Access Compliance Report

Public Rights-of-Way

(Curb Ramps)

Intersection ID: 19275	Main Street: PEBBLESTONE_DR	Cross Street: VILLAGE_LAKE_DR	Location: NE
ADA ID: 5F146E24A74C	Ramp Type: PerpDiag	Initial Pass/Fail: Fail	Overall Compliance: No
		Severity Score: 12.5

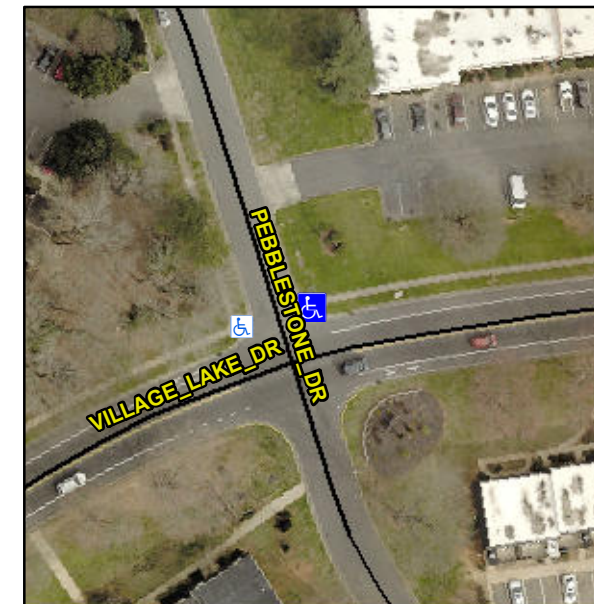
Not Found, R304.2.2

Compliance	Description	Data	Compliance	Description	Data
N/A	Ramp Length (in)	84.0	No	Ramp Slope (%)	9.6
Yes	Ramp Width (in)	48.0	Yes	Ramp XSlope (%)	0.1
N/A	Flare Type LT	N/A	N/A	Flare Type RT	N/A
N/A	Flare Slope LT (%)	N/A	N/A	Flare Slope RT (%)	N/A
N/A	Flare Traversable LT?	N/A	N/A	Flare Traversable RT?	N/A
N/A	Landing Length (in)	N/A	N/A	DWS Provided?	N/A
N/A	Landing Width (in)	N/A	N/A	DWS Contrast?	N/A
N/A	Landing Slope (%)	N/A	N/A	DWS Length (in)	N/A
N/A	Landing X Slope (%)	N/A	N/A	DWS Full Width?	N/A
N/A	Landing Curb? (Y/N)	N/A	N/A	DWS Offset (in)	N/A
N/A	Shared Landing?	N/A			
N/A	Gutter Ponding?	N/A	N/A	Gutter Slope (%)	N/A
N/A	Gutter Lip Ht (in)	N/A	N/A	Gutter X Slope (%)	N/A
N/A	Painted X Walk1?	No	N/A	Painted X Walk2?	No
	X Walk 1 Direction	To W		X Walk 2 Direction	To S
N/A	X Walk 1 Width (in)	N/A	N/A	X Walk 2 Width (in)	N/A
	X Walk 1 Slope (%)	0.8		X Walk 2 Slope (%)	1.5
	X Walk 1 X Slope (%)	2.0		X Walk 2 X Slope (%)	2.0

Remove & Replace Curb Ramp With Two New Directional Ramps or Equivalent.
